## SERVICE BULLETIN

**Subject: PBFTVS.USB700 – END OF LIFE (EOL)**

**Subject: PBFT / PBT-0111 and PBT-0112 Strain Gauge Upgrade Kits**

# Strain Gauge Retrofit Procedure

## 2. Remove Mount Plate

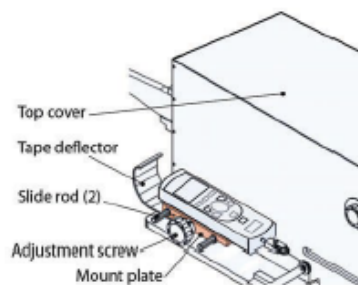
If an old-style mount plate is in use, it will need to be replaced to maintain proper peel angle.

1. Inspect the PBFT to discover which mount plate is currently in use:
  - a. If the new, thicker (1") mount plate is already in use, skip to [5. Align Tape Clip](#) (pg 3).
  - b. If the old model (0.18" thick) is in use, it will need to be replaced with the new (1" thick) model included in the kit. Go to step 2.

Only the NEW style mount plate should be used with the new strain gauge model.

2. Remove the old-style mount plate:
  - a. Remove all power from the PBFT.
  - b. To expose the Collar securing the strain gauge Adjustment Screw, remove the screws in the Top Cover using a 3/32" Allen wrench, and then, being *careful not to put tension on the ground wire attached to the cover*, slide the Top Cover back away from the front cover.

- c. Loosen the Set Screw in the Collar using a 5/64" Allen wrench, slide the Collar and Washers from the Adjustment Screw, and set them aside.
  - d. Pull the Adjustment Screw and Mount Plate away from the front of the PBFT and off the Slide Rods.
  - e. Unscrew the Adjustment Screw and Tape Deflector from the old mount plate and set both items aside.
